## **Response to Comments**

# **Integrated Disposal Facility Operating Class 3 Permit Modification**

For the **Nuclear Waste Program**

May 2023, Publication 23-05-004

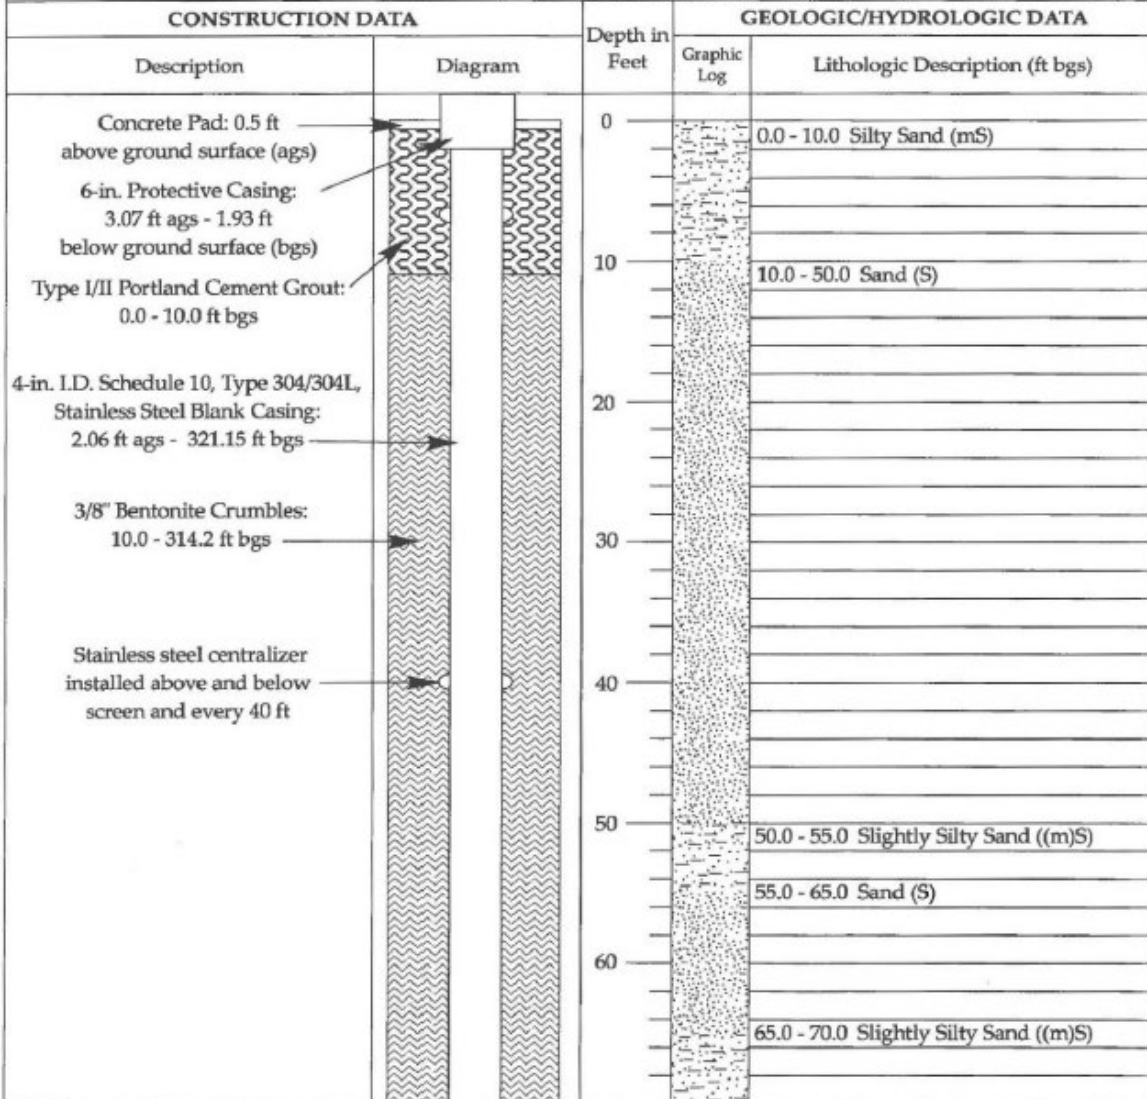
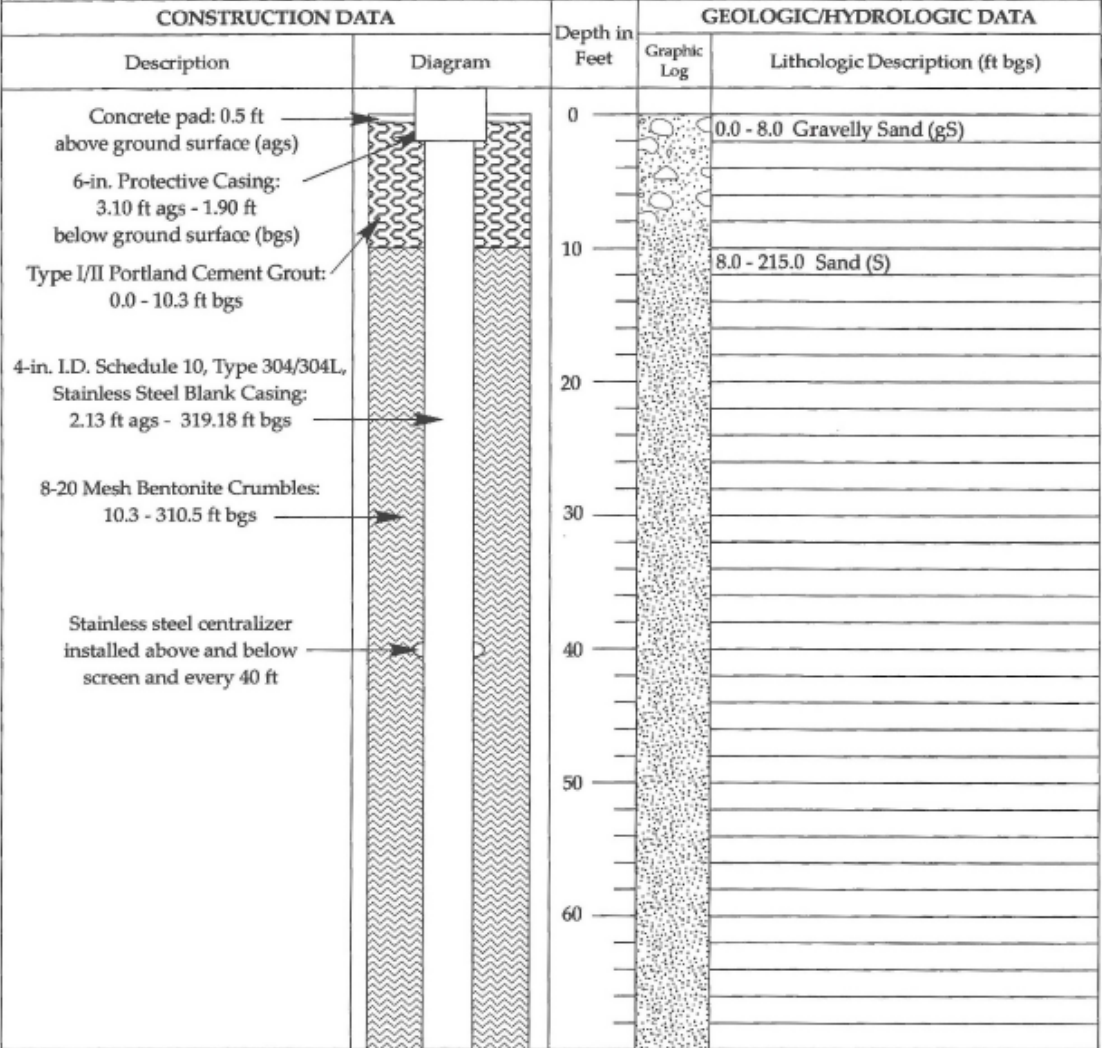
Appendix DC, Section DC.1, Introduction, p. DC.3, lines 18-19, and Figures, pp. Appendix DC.9 - Appendix DC.15. Figures DC-1, DC-3, and DC-4 provide construction and completion summaries for the existing network wells

4. Page Addendum D.71 (the first D.71), Table D-5, footnote “b” for Wells 299-E17-56, 299-E17-57, and 299-E24-164: “Water-table elevation in this well has not been corrected for deviation of boreholes from vertical, which may cause the reported head to be less than the actual head.” (i) When will the elevation for these wells be corrected? (ii) The elevation for the upgradient well 299-E17-57 is listed as 121.89 m (NAVD88) for 8/14/2020 in the table. This value is 1.00 m greater than that in the HEIS database (Figure 2, HEIS data accessed 8/23/2022). Which one is correct?
